CUBEX LTD. PRODUCT UPDATE

BULLETIN: PU-0015

SUBJECT: BOOSTER INLET ASSEMBLY CM48300-ARR

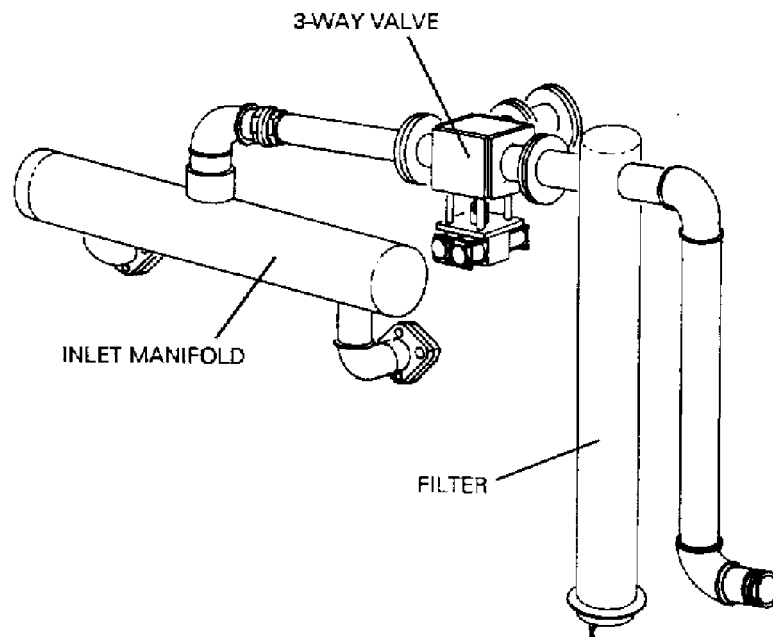
INFORMATION: Cubex has reconfigured and enlarged the inlet assembly to our boosters.

The larger mine air filter improves overall partical filtration, but the advance is in water separation. With its much deeper body the filter prevents water, that has already been separated from the air, from being agitated and reintroduced into the stream. The result is better valve life and less water contamination of compressor oil.

The inlet size is 3" instead of 2". This results in less pressure drop from the line to booster. Therefore, inlet pressure at the booster is higher, the result is more production of sir and less heat generation.
